City of Fredericksburg

Planning and Zoning Meeting Agenda
Wednesday, May 6, 2026 ~ 5:30 PM
New City Hall at East Campus
2818 E. U.S. Hwy. 290
Fredericksburg, Texas 78624

RE: SP-2602, Review Comments for the La Posada Site Plan located at 111 FM2093, Fredericksburg, Texas, 78624

RE: SP-2603 Review Comments for the Bethany Lutheran Site Plan located at 110 West Austin,
Fredericksburg, Texas 78624

SITE DIMENSION PLAN

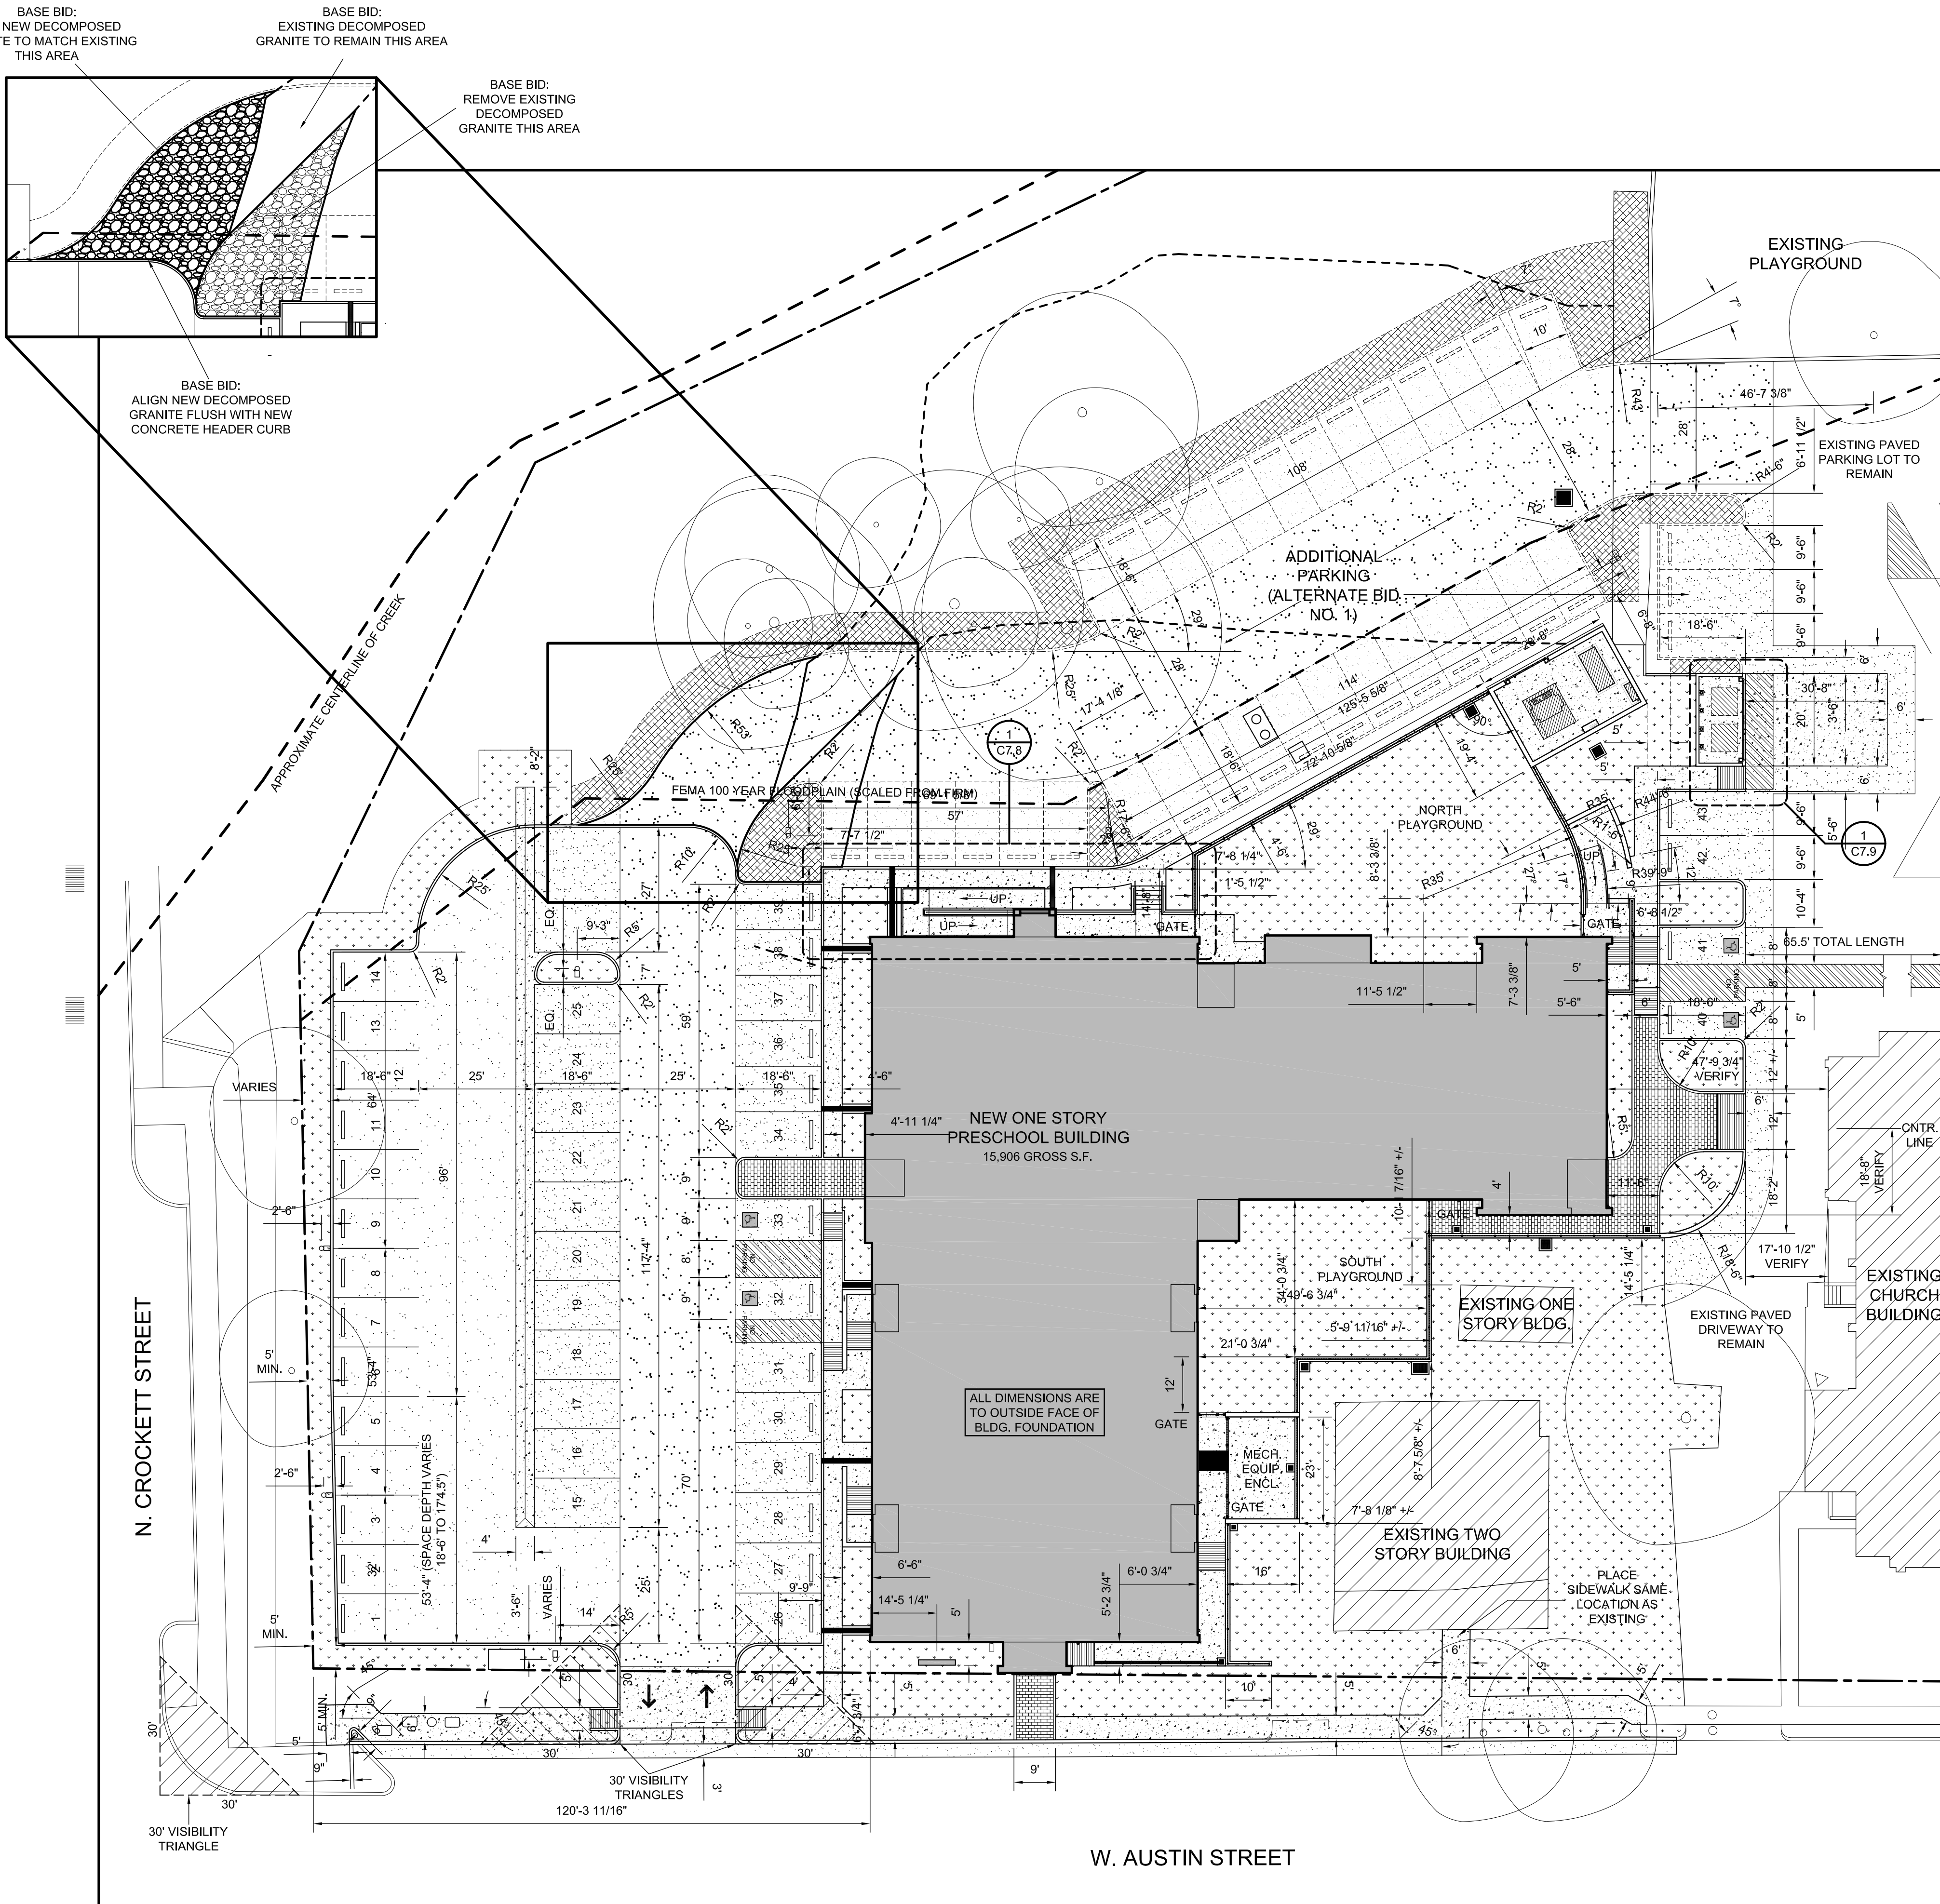
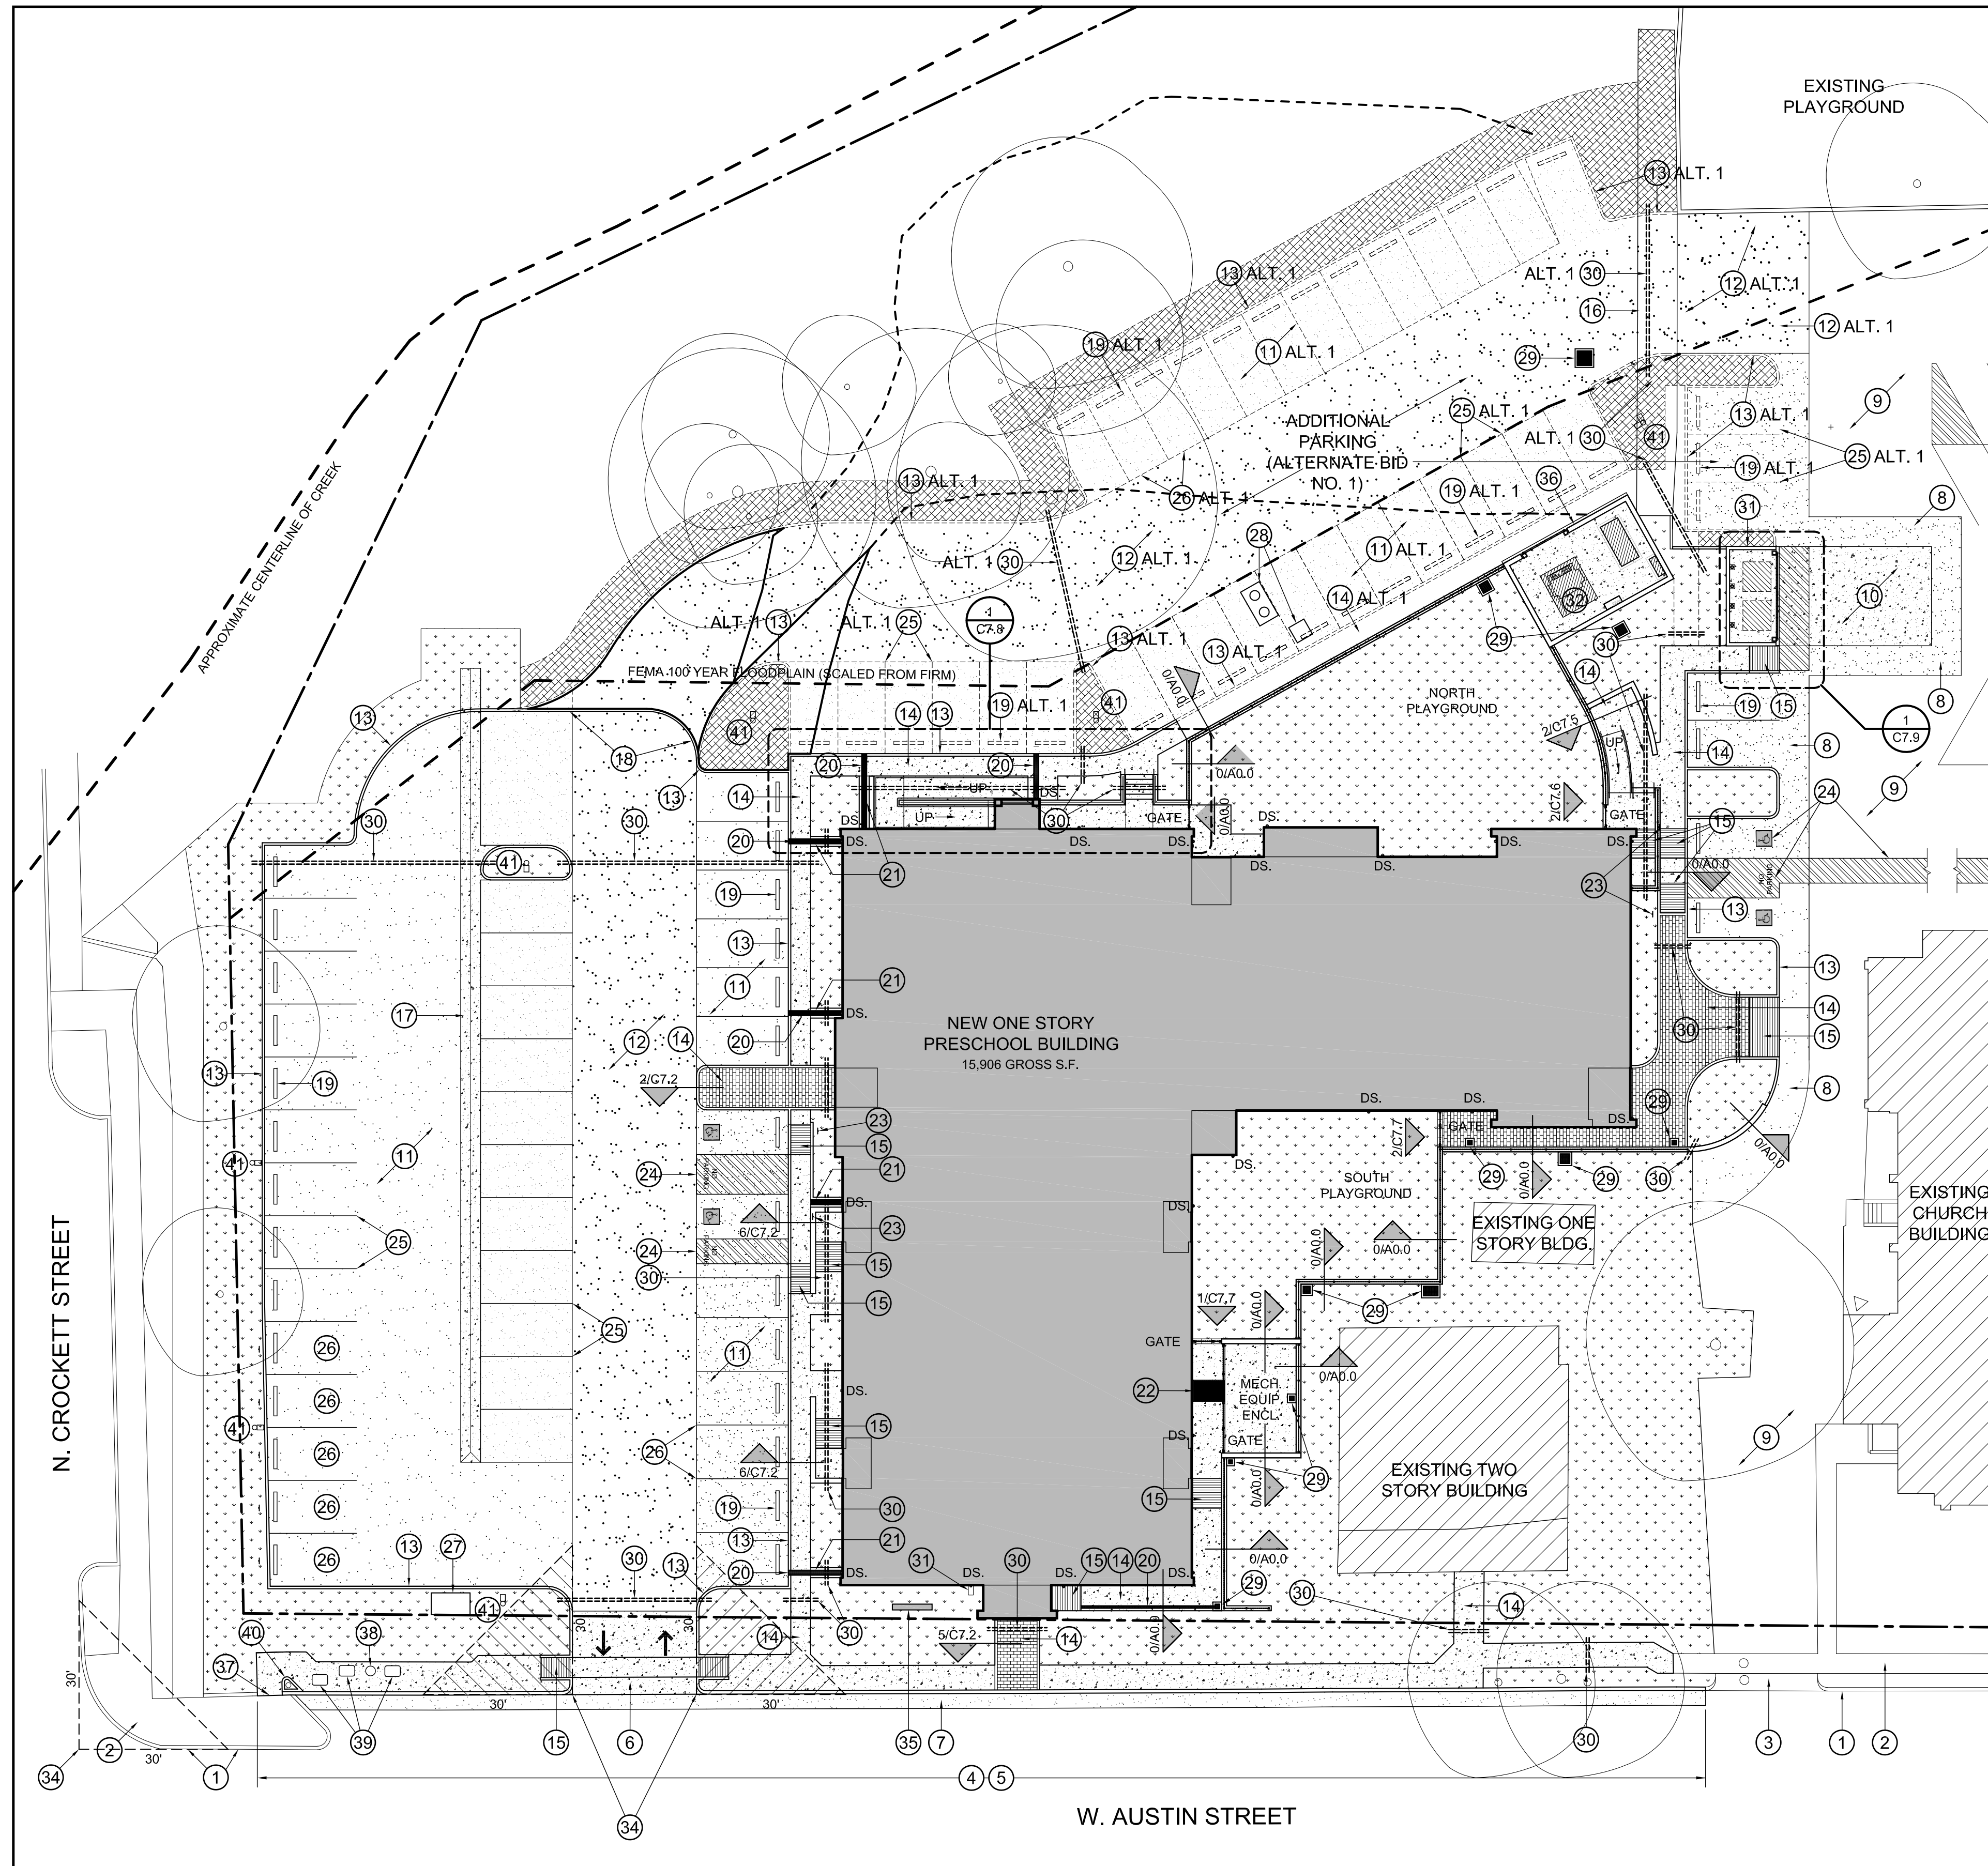
1. **Comment:**
Provide landscaping, including location, size and species of existing trees on site, square footage of all proposed landscaping areas, Section 7.920.

Response:
One exterior ground sign is proposed, and it has been added to the attached updated Site Development drawings.
3. **Comment:**
Submit proposed exterior lighting, including fixture type. Article XV – Outdoor Lighting.

1. **Comment:**
Submittal of civil construction plans will be required. Items like utility connections and parking will be reviewed in detail at that time.
Response: Civil construction plans and specifications will be provided for permitting.
2. **Comment:**
Please make sight visibility triangles 30’ X 30’.
Response: 30’ X 30’ visibility triangles have been added to the updated Site Development drawings.
3. **Comment:**
Please note that public sidewalks must be 5-foot wide.
Response: All new public sidewalks will be 5’-0” wide and are shown on the updated Site Development drawings.

Response: Landscape plans compliant with Section 7.920 will be submitted with final plans and specifications for permitting.
2. **Comment:**
Include the location of signs, Chapter 29.
